Dublin Cycling Campaign

January 2014

Submission by Dublin Cycling Campaign on the Proposed Road Development ESB Link Road and Link to Arena Road, PC/07/13, Nov-2013

Figure 2: Proposal area orientated
Top = North, Bottom = South

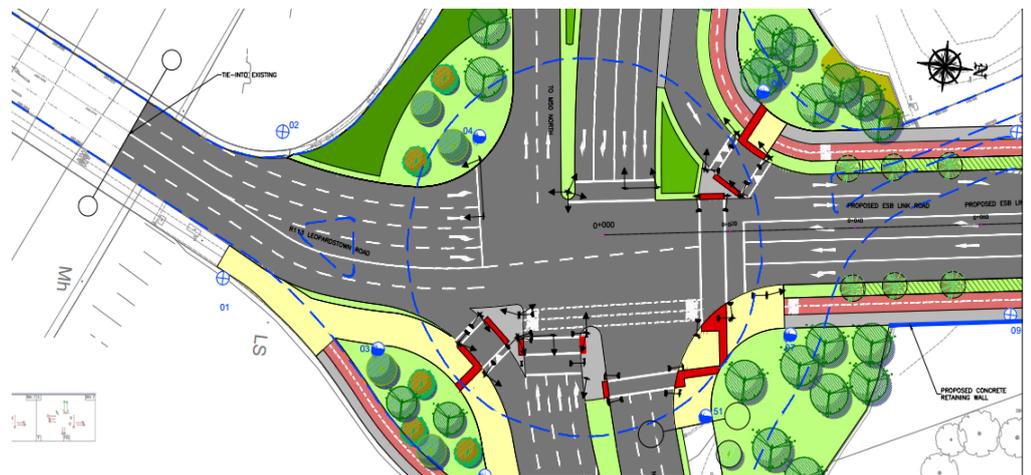
We feel the extent of the proposal area needs to be widened to include how cyclists advance from Murphystown Road to the ESB Link Road and to Leopardstown Road. Currently the proposal shown in blue in figure 2 doesn't take into account the Murphystown Road shown as orange box 1 in figure 2, yet this is an important consideration for cycling as the current design assumes that cyclists will be located in the off road cycle track.

However many cyclists from Murphystown Road will choose not to use the toucan crossing and stay on road to approach the new main junction with the M50 and therefore will progress through on the roadway with motorised traffic.

We feel therefore that there is a requirement to add on-road cycle lanes and through the new junction and ASL to cater for Northbound cyclists going straight through the junction and turning right on to Leopardstown junction.

This may also mean tightening the turning radius for left turning vehicles on to the M50 to reduce speed conflict. It will also mean adding a ramp to the North East cycle track to allow

Figure 9: Proposal area orientated Top = North, Bottom = South

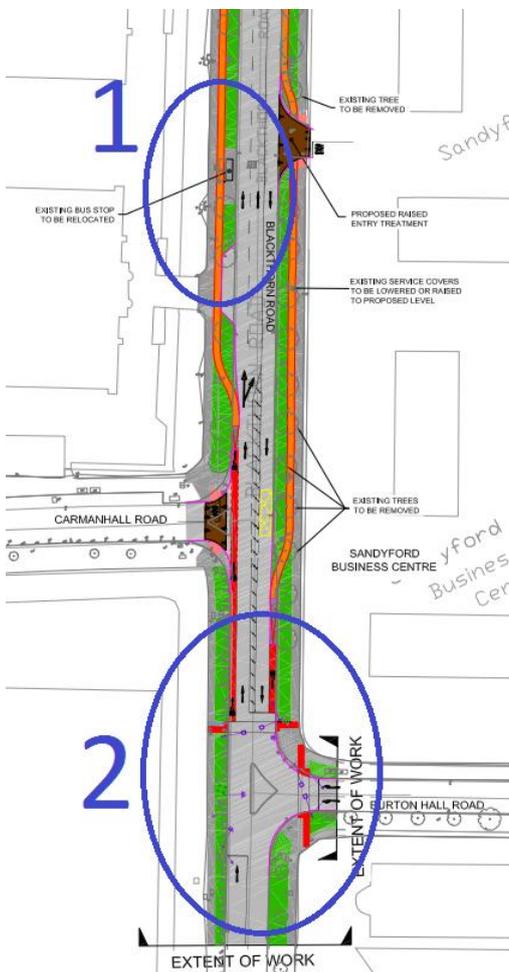
There is a concern that the tie in to Blackthorn Road East for cyclists has some unacceptable items in the current design and from recent works. These are just outside the proposal area, but are an important part of the wider cycle infrastructure in the area. This is highlighted in the orange box number 2 in Figure 9.

The design on Blackthorn Road East is quite astonishing in an era of higher standards espoused by the National Cycle Manual and in an era of DTA policy makers having aspirations for a quality cycle infrastructure on a par with Dutch best practice.

The layout in question is a legacy of recent works which removed high quality on-road cycle tracks to make for a third lane on the roadway. Poorly designed off-road cycle tracks were then constructed on existing grass verges. One particular issue is the placement of the cycle track inline with a bus stop, requiring cyclists to use the footpath to weave around the obstacle. This is highlighted in blue as number 1 in Figure 10 and with a picture taken recently in January 2014 shown in Figure 11. This is simply an unacceptable layout for cyclists and pedestrians. The bus shelter should be moved to the back of the footpath or removed altogether.

In the current scheme proposal there is nothing showing how the cycle lane will integrate properly in either direction with the junction of Blackthorn Road East and Burton Hall Road. This is highlighted in blue as number 2 in Figure 9 and in blue in Figure 10. The remainder of Blackthorn Road East needs to be brought into the proposal in order to correct the cycling facilities from the recent works.

As the nature of the cycle facilities at the tie-ins need to be examined in the context of the wider cycle infrastructure and any improvement works required should be carried out as part of the scheme.

Figure 13: Slip turns in the current design

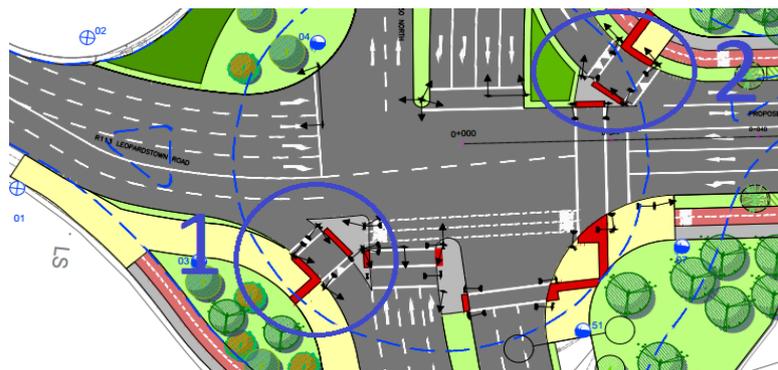
The design shows two significant slip turns, but the Design Manual for Urban Roads and Streets recommends that designers of new or upgrade road schemes should “omit left turn slips, which generally provide little extra effective vehicular capacity but are highly disruptive for pedestrians and cyclists”, section 4.4.3 of DMURS.

Slip turns allow motorists to quickly turn, thus putting pedestrians and cyclists in greater danger and they increase the number of crossings pedestrians must navigate.

The slip turn from Leopardstown Road Murphystown Way needs to be omitted from the design, shown in blue number 1 in figure 13. This will remove the need for an extra signalised crossing for these priority road users and make it easier to cross the Leopardstown Road to continue on their journey.

Other official advice in the National Cycle Manual, produced by the National Transport Authority, says that the slip turns “often gives drivers an unreasonable sense of priority,” and allows “vehicles to take corners at higher speeds” and “restricts views of cyclists and pedestrians”, section 4.5.5 of NCM.

Figure 17: Blackthorn Road West proposal

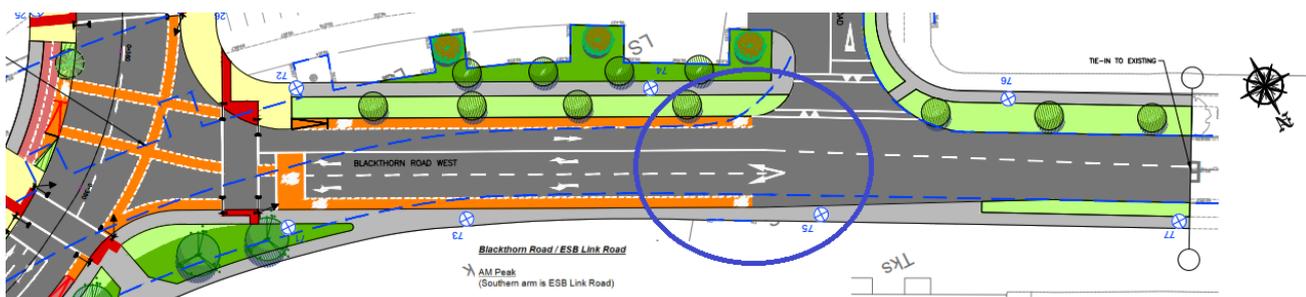
The current proposal along Blackthorn Road West shows incomplete cycling provision. In figure 17 the current proposal shows the cycle start and end in blue. However, in figure 18 there is existing cycling provision that ends just short of the proposal area. It would appear the current proposal will create a disjointed cycling provision along Blackthorn Road West.
